PCN-20190827 TE0706-03 Under Voltage Protection Change

Company	Trenz Electronic GmbH
PCN Number	PCN-20190827
Title	TE0706-03 Under Voltage Protection Change
Subject	Trenz Electronic TE0706 Hardware Change
Issue Date	2019-09-05

affected product
TE0706-03

#1 Replaced R34 by 953kOhm and R38 by 147kOhm

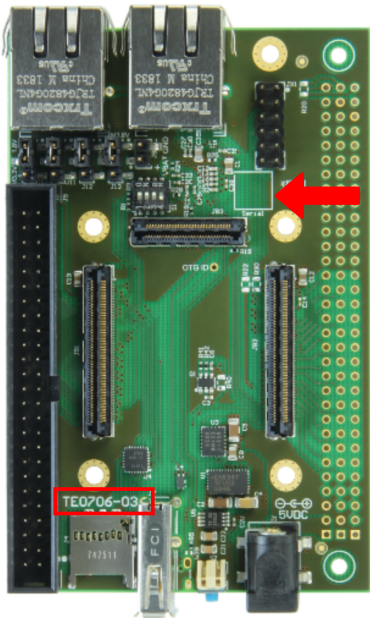
Type: BOM change

Reason: Large start up currents led due to adverse conditions (e.g. weak powersupply, long wires, increased contact resistance) to a voltage drop below the under voltage lock out limit of the input protection circuit.

Impact: Under voltage protection limit is decreased to 4.06V, which gives a larger margin for a voltage drop during start up.
